PUBLIC UTILITY COMMISSION OF OREGON
STAFF REPORT
SPECIAL PUBLIC MEETING DATE: March 16, 2020

SUBJECT: PORTLAND GENERAL ELECTRIC:
(Docket No. LC 73)
Acknowledgement of 2019 Integrated Resource Plan

Figure 1: Renewable Resource Portfolio Additions⁸⁴

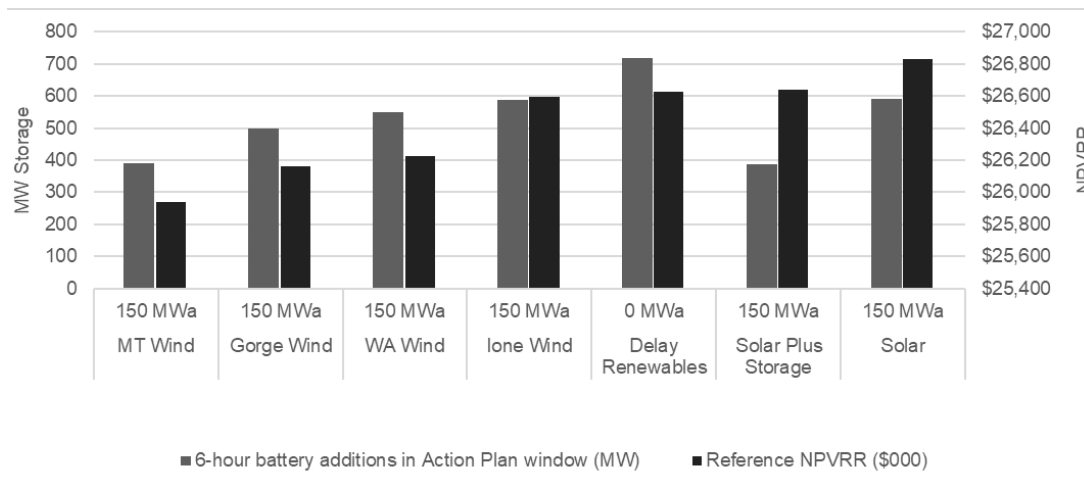
Examination of PGE’s renewable resource portfolios shows that the optimal dispatchable capacity resources—as well as the portfolio’s performance—is closely linked to the attributes of the renewable resources acquired. For example, the portfolio constrained to add 150 MWa of Gorge Wind requires 50 MW fewer in storage capacity additions and provides \$64.5 million of additional benefits compared to adding 150 MWa of Washington Wind.

However, the Washington Wind proxy resource performs notably better than the Gorge Wind on an energy and net resource value basis (roughly 22 percent). This enforces Staff concern that separately pursuing energy resources based on the forecasted energy value places ratepayers at an even higher risk of overbuilding across resources.

Figure 2: PGE 2017 Proposed Renewable Glide Path

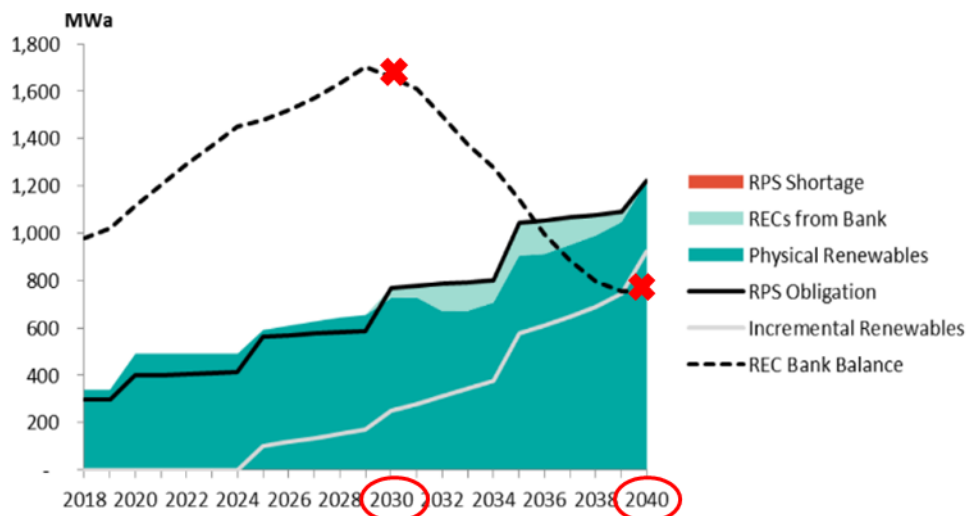
PGE's proposed physical compliance strategy is a large departure from the last IRP. In LC 66, PGE proposed a mix of RECs and near-term resource acquisitions to create a glide path for long-term RPS compliance, as shown in the figure below.¹⁴⁸

PGE's proposed shift to a physical compliance strategy in the 2019 IRP nearly doubles the forecasted REC bank size by 2030, and by 2040 the REC bank is about seven times larger than the glide path proposed in 2017.¹⁴⁹ For perspective, PGE will have roughly four times as many RECs in its bank than its reference case load forecast in 2040. This means PGE could have enough RECs stored up—already paid for by ratepayers—to meet eight years' worth of its 50 percent RPS obligation.¹⁵⁰

Figure 3: PGE 2019 IRP Preferred Portfolio REC Utilization¹⁵¹

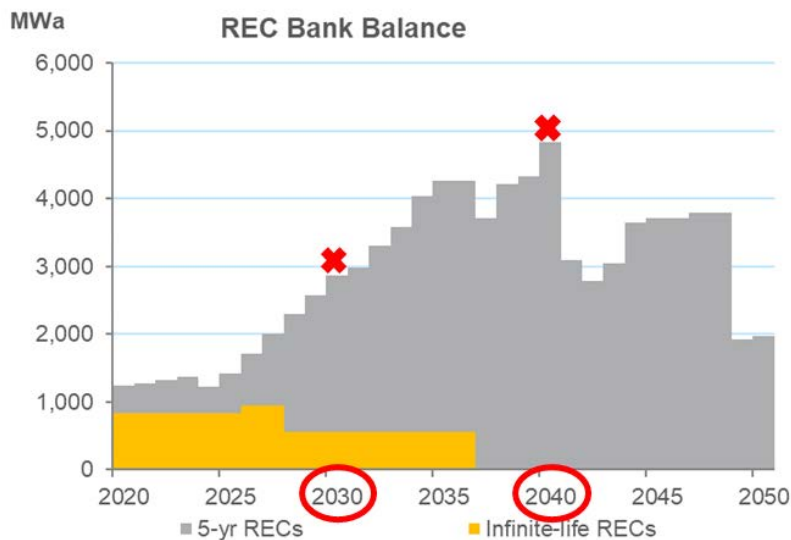
Staff appreciates all of the additional analysis conducted by PGE on issues related to RPS need and its physical compliance strategy. However, we agree with AVEC that this approach overstates the near-term need for PTC wind in an effort to help bolster the more long-term and thus less concrete benefits related to the economic opportunity argument associated with this resource. In this sense, we disagree with the analysis of NVEC, RNW, and CUB.

PGE presents analysis clarifying that the model can still choose to use banked RECs. However, the physical compliance requirement means that the use of banked RECs cannot actually defer the model's decision to add new resources—it simply determines which RECs are most cost-effective to retire. To this end, if renewables are projected to be so much cheaper than banked or unbundled RECs, then Staff is left wonder why the physical compliance requirement was necessary in the first place.

- Not model a physical compliance requirement in the next IRP;
- Require PGE to model a reasonable amount of banked RECs, like in LC 66, as part of any revised RPS need forecast in upcoming RFPs or the 2019 IRP update;
- Require PGE to model the use up to 20 percent unbundled RECs to meet RPS as part of any revised RPS need forecast in upcoming RFPs or the 2019 IRP update;
- In the next IRP, develop and perform a sensitivity on the preferred portfolio that uses 20 percent unbundled RECs; and
- Open a contested case to determine how to best return value to ratepayers from accumulated unused RECs.

Figure 4: Historic Commercial and Industrial Load¹⁶⁸

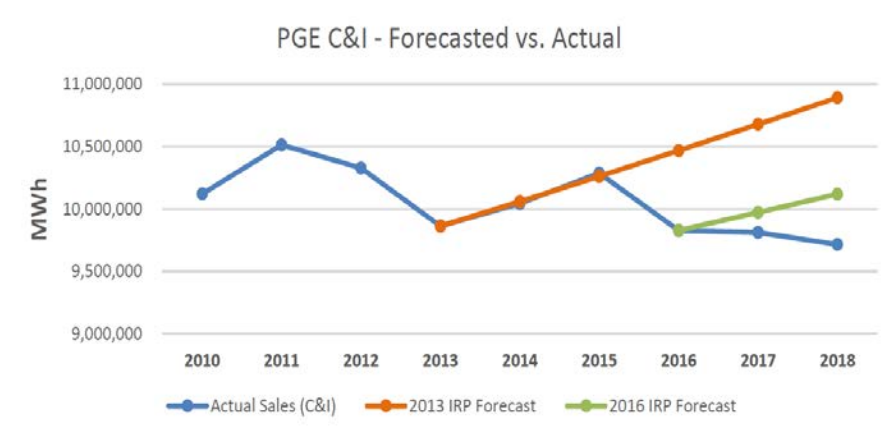
load growth of 0.5 and 1.9 percent for commercial and industrial customers stands in contrast to recently observed annual growth rates.

Acknowledge PGE's load forecast subject to the following modifications:
